L'usine Fashion (Mawna Unit)

17 April, 2016

Client Summary Report

Discrepancy with As-build drawing

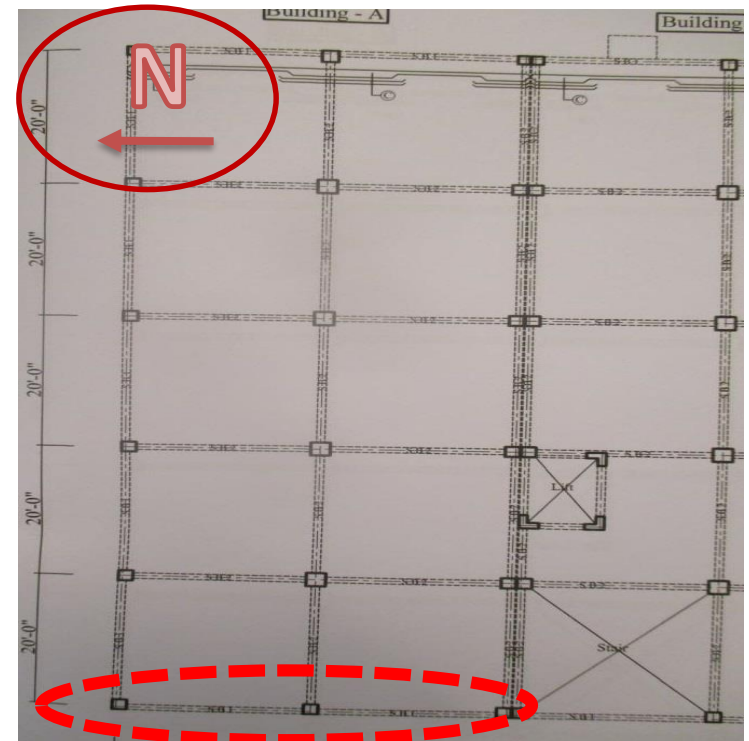
Main building Part-A Discrepancy with As-build drawing

As build drawing shows C1-(381 x381mm) with 8-20mm $\varnothing$ bar. But actually column size found (457.2 x457.2mm) with 12-20mm $\varnothing$ bar. As build drawing needs to be revised as per actual site condition.

- Building engineer to check, collect information and produce accurate and fully complete as-built documentation.

Missing beam in Ground floor

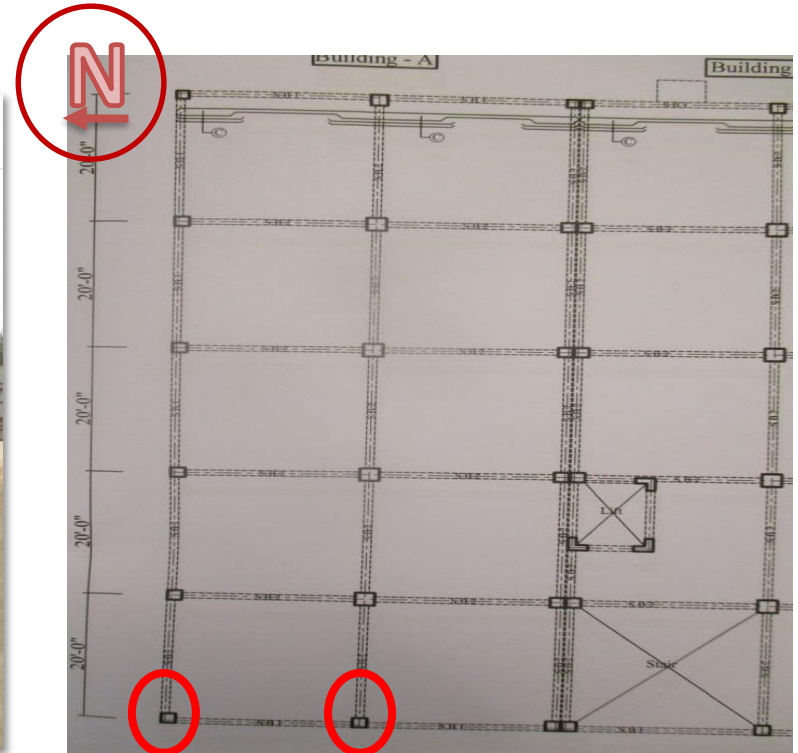
Missing beam in Ground floor

As-build drawing beam layout plan shows presence of beam in ground floor in marked area but practically no beam found. As-build drawing needs to be corrected as per present factory condition.

- The Building Engineer shall provide calculations showing the structural adequacy of members for missing beam

- Factory Engineer to survey the building and prepare as-build drawing
- Prepare load plan and continue to implement

Columns at risk of vehicle impact

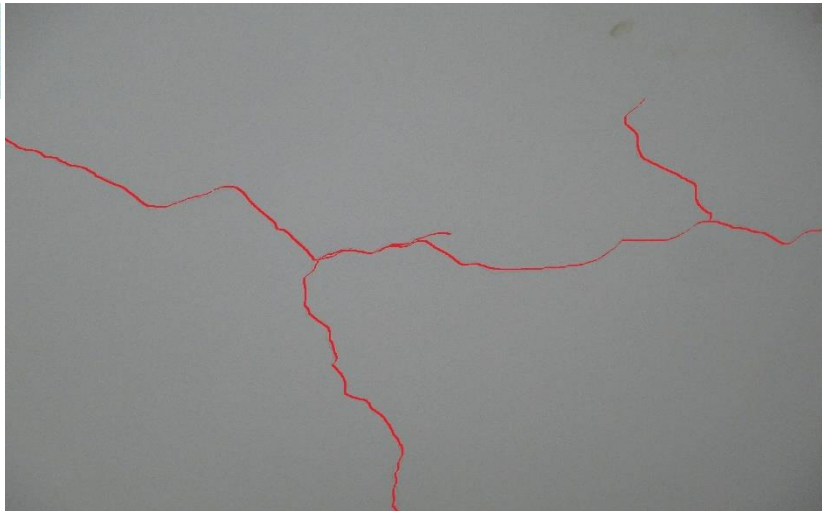
Columns at risk of vehicle impact

Column at ground floor level are susceptible to impact loading from vehicles. Marked columns (which carry the building above) have no protection against vehicle impact.

- Column to be protected from vehicle impact.

Cracks in ground floor slab soffit

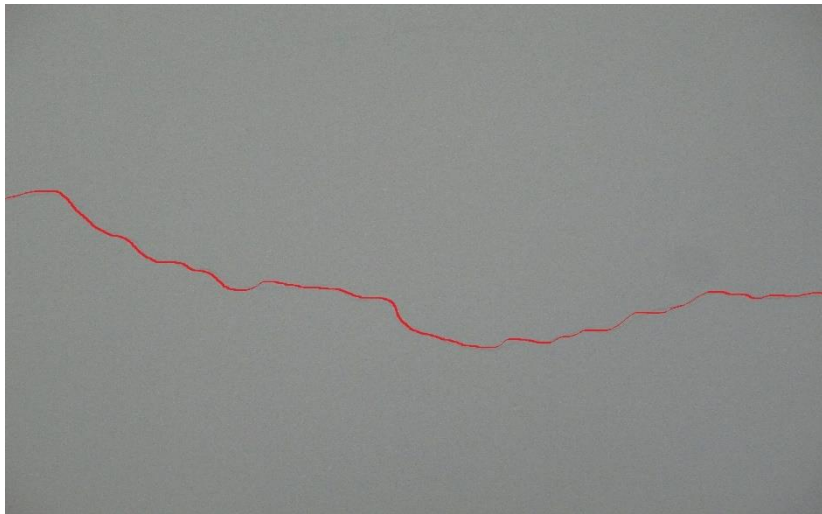
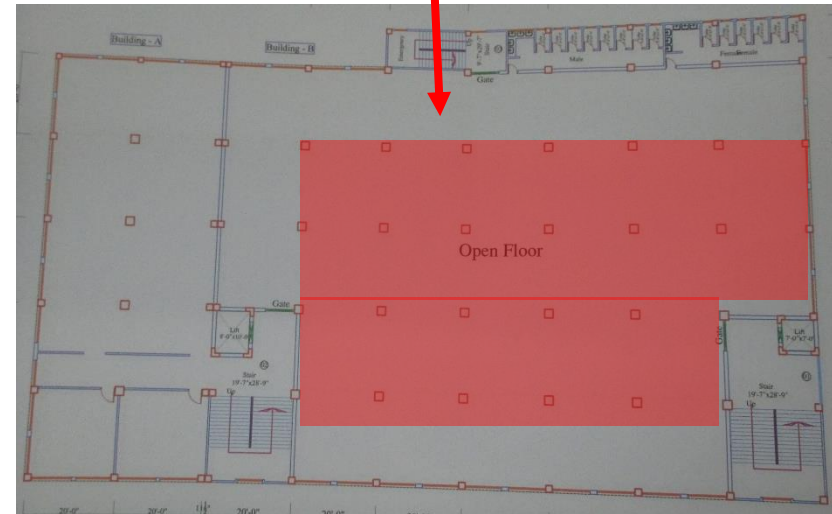
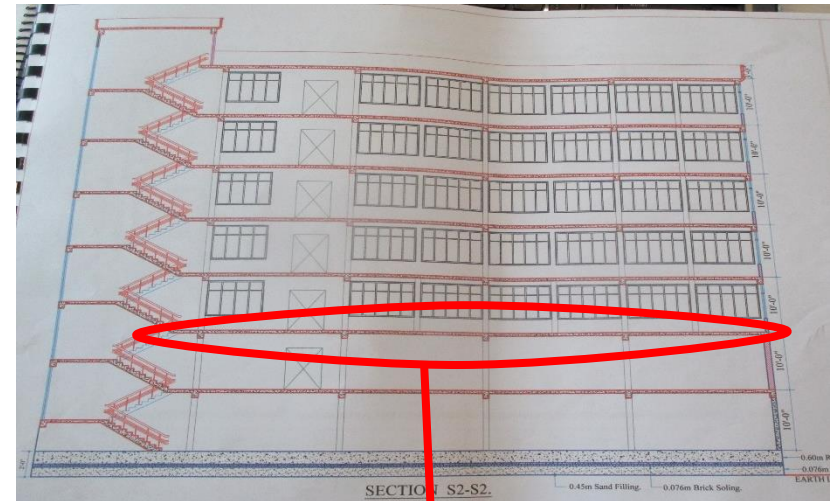
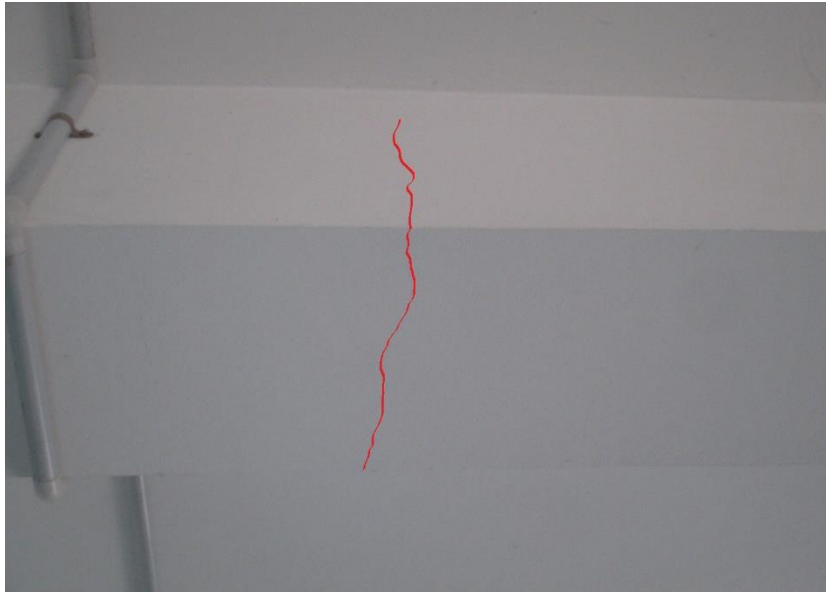
Cracks in ground floor slab soffit

Cracks found in marked areas

- Factory Engineer to survey and identify the cause of cracking

- Building Engineer to provide calculations showing the structural adequacy of Slab and Beams

- The distress found is recommended to be repaired with suitable proper methods
- Prepare load plan and continue to implement

Cracks in ground floor beam

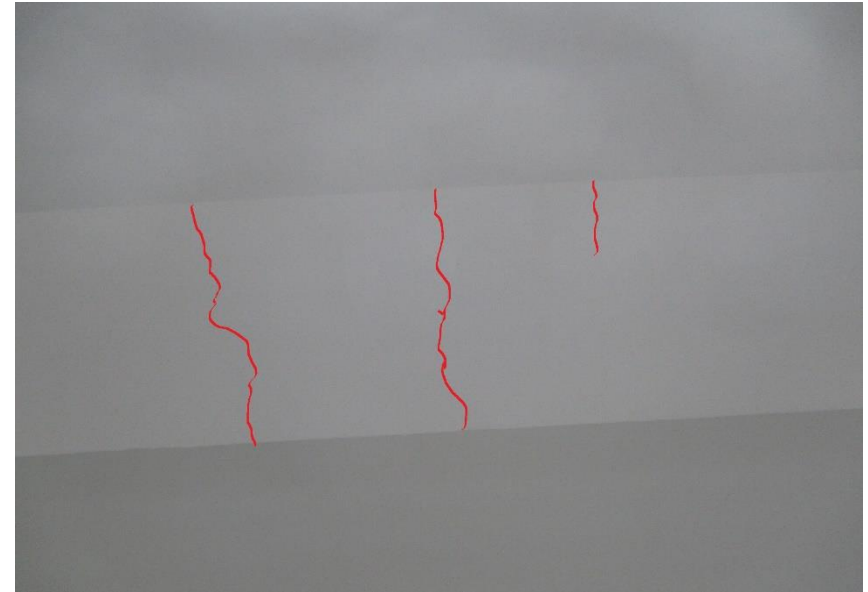
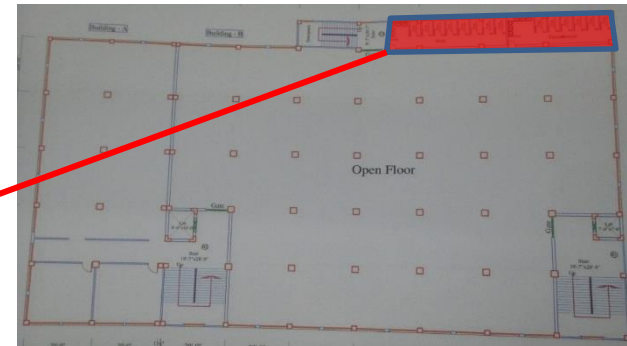
Cracks in ground floor beam

Hairline cracks found in ground floor beam and slab soffit. Upper floor used as jacquard section and almost 150 machines are there. The cause of cracking must be checked and suggested if the slab is adequate to bear loading from upper floor.
